Partial correction of the report on results of earthquake response analysis of Unit 2 at Fukushima Daini Nuclear Power Station using observed seismic data during the Tohoku-Taiheiyou-Oki Earthquake

Figure 1 Explanation of the evaluation work flow and the inconformity event

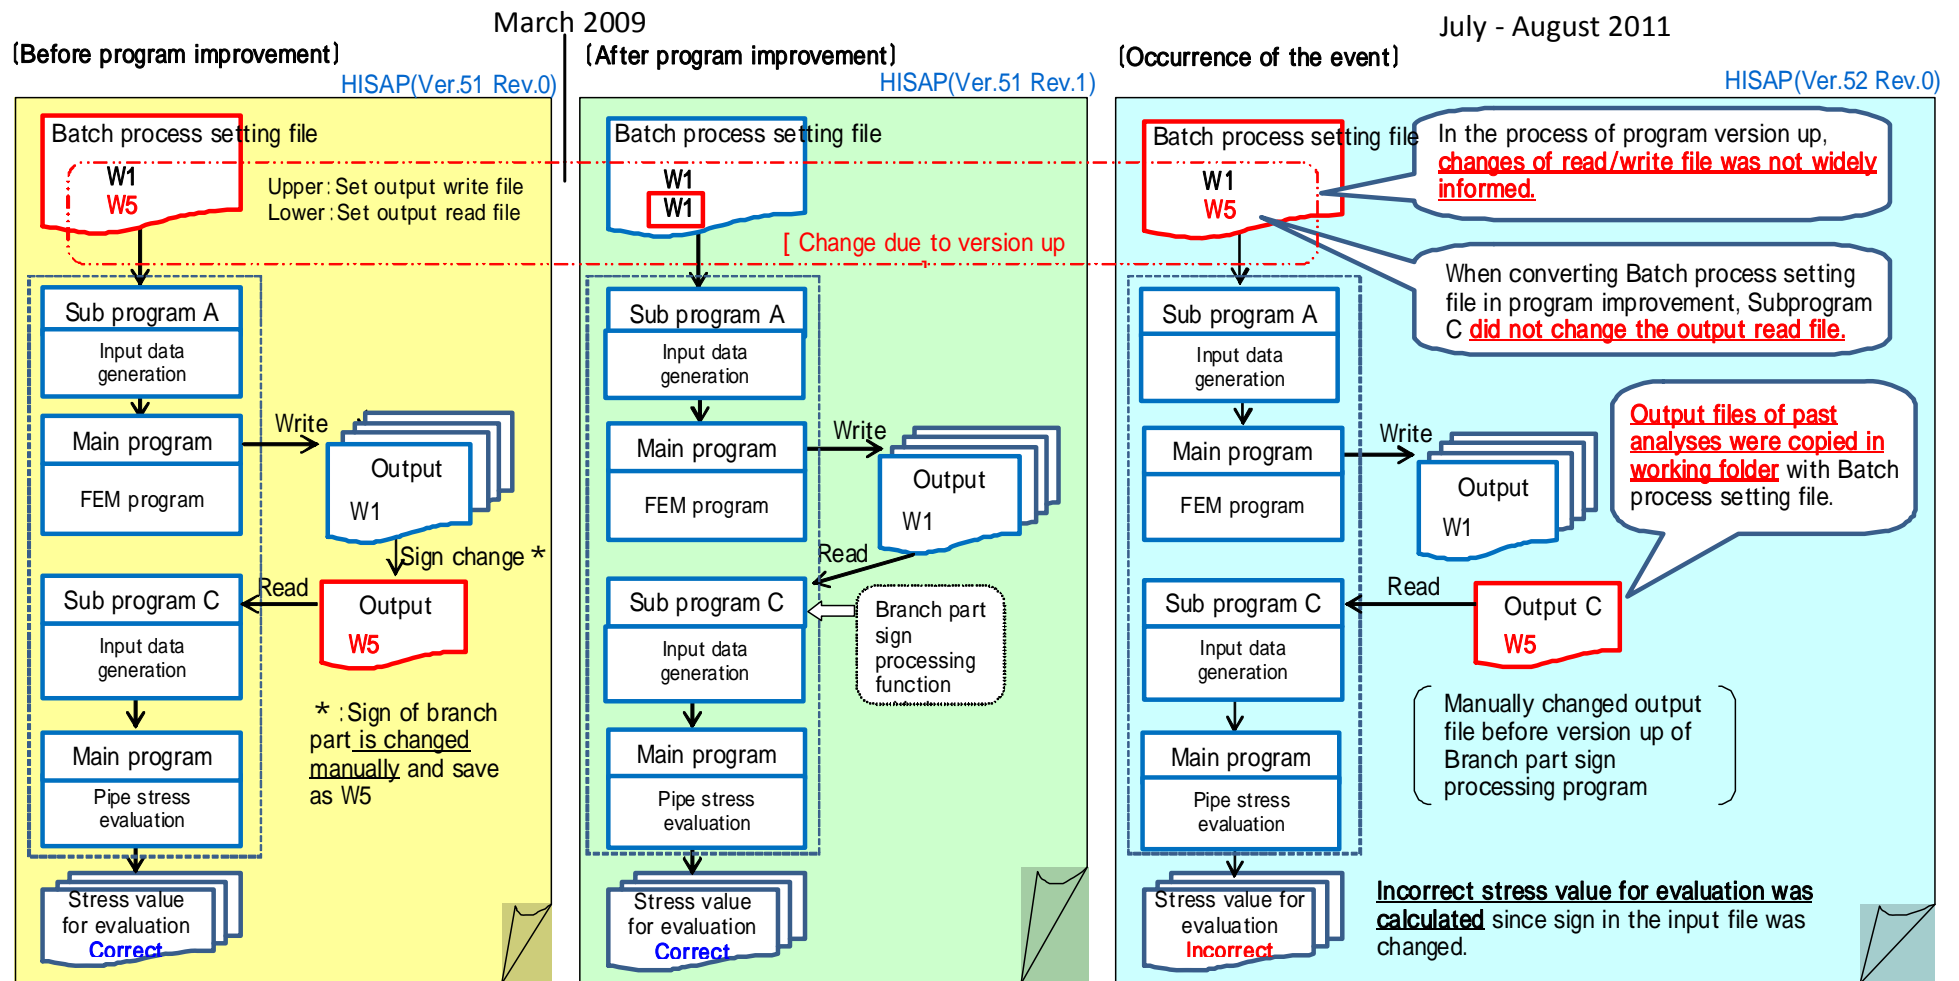
At that time, the file was changed by hand as an emergency measure. (Refer to Figure 1 [before program improvement]) Later, the defect of the sub program C was modified and HISAP was revised under the name of Ver.51 Rev.1. This update realized to directly read files generated by the main program B into the sub program C and to calculate stress of piping arrangement properly. (Refer to Figure 1 [after program improvement])

HISAP (Ver.52 Rev.0) was developed, diverting from the batch process setting file which was utilized when the emergency measure was made against the past inconformity. For that reason, the name of the file read by the sub program C was changed regarding the original batch process setting file. In addition, inside the diverted work folder, not only files generated by the main program B but also files modified by hand existed.

To properly conduct the analysis this time, the modification of the designation of the file name to be read by the sub program C should be done, but weren't done. Moreover, since not only the batch process setting file but also all the other files inside the original work folder were copied to the work folder for this analysis, the sub program C read in the file whose code was changed and the false stress was calculated. (Refer to Figure 1 [Occurrence of the event])

- At the Hitachi-GE, they have to announce the changes when the calculation program upgrade. Additionally, they have to describe changes of analysis procedure as precaution on operation procedure when the analysis procedure changed.
- At Hitachi-GE, they have to confirm all items of input data relating to valuation of input data. When they don't conduct confirmation of all items, they have to conduct confirmation of input data by evaluate the appropriateness for exclusion of some items from confirmation coverage.
- At TEPCO, we try to rise caution by describing this nonconformity as nonconformity case on applicable document of our manual.
- Hereafter, we will confirm the conduction of valuation of input data has conducted certainly by Hitachi-GE.
